SERVICE BULLETIN

SUBJECT: Norco, Inc. A2972-1 and -2 Strut Assembly Rework to A2972-11 and -21

A 2972-78-2

FIGURE 1 TIP DIMENSIONS

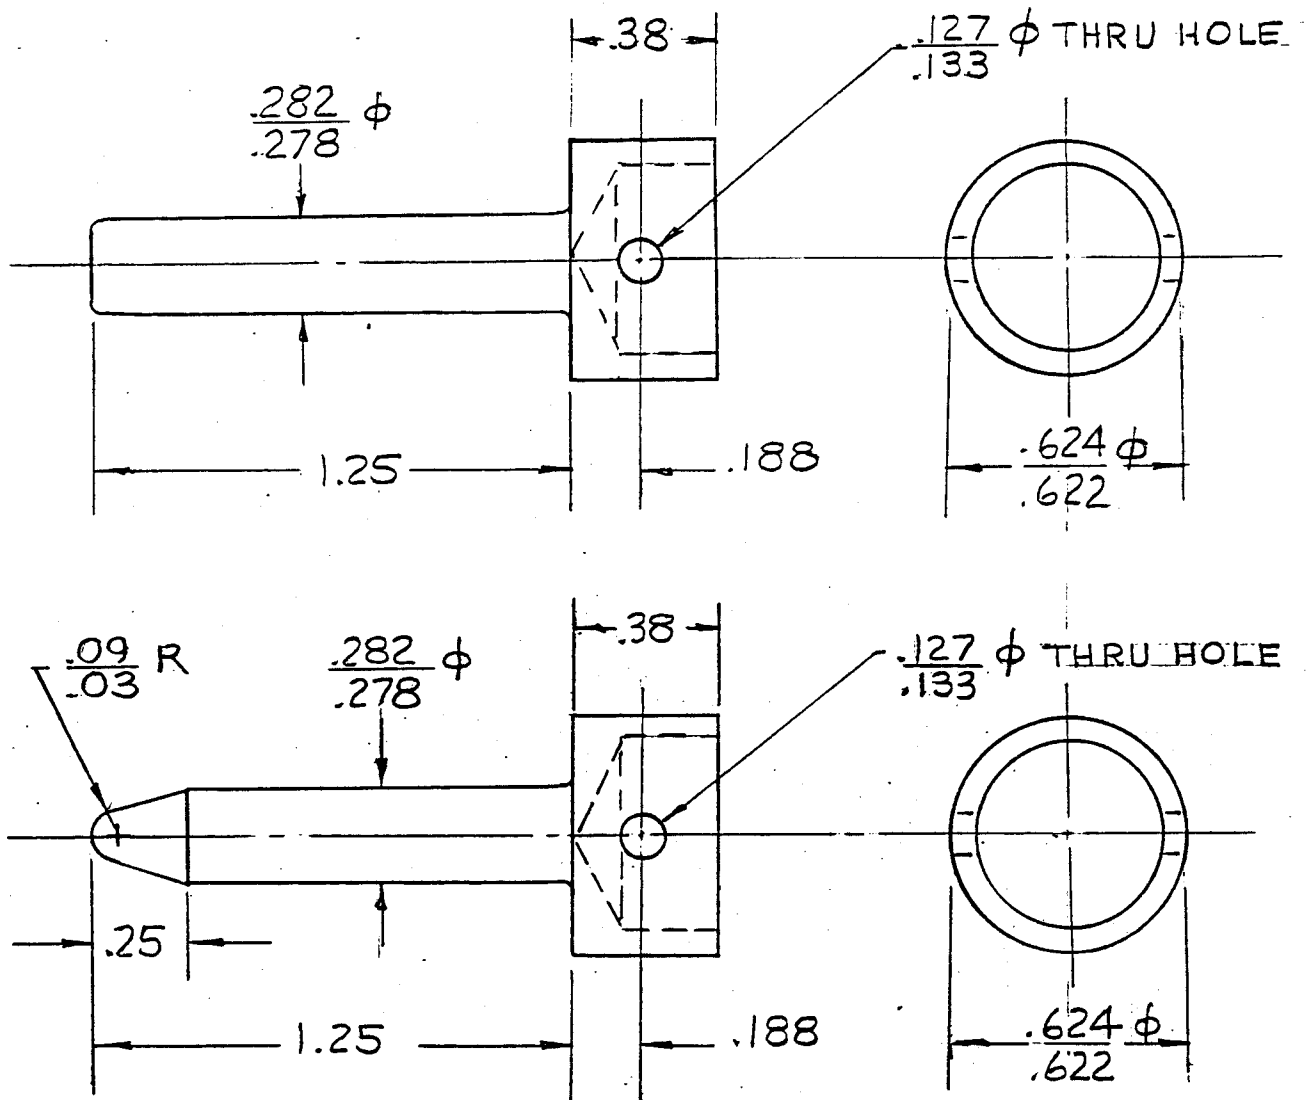
Allow A2972-1 and -2 Strut Assemblies to be reworked to A2972-11 and -21 tip configuration.

- 1) Remove tip by drilling out rivet in end of lock rod using a 0.125 inch diameter drill. Drill rivet on side with undeformed head.
- 2) Remachine tip end to new configuration shown in figure 1.
- 3) Repassivate per QQ-P-35
- 4) Insert tip into hole in lock rod and align rivet holes.
- 5) Insert a new rivet, part number MS20613-4C16, and spin or set head. Check that rivet head is properly formed without cracks.
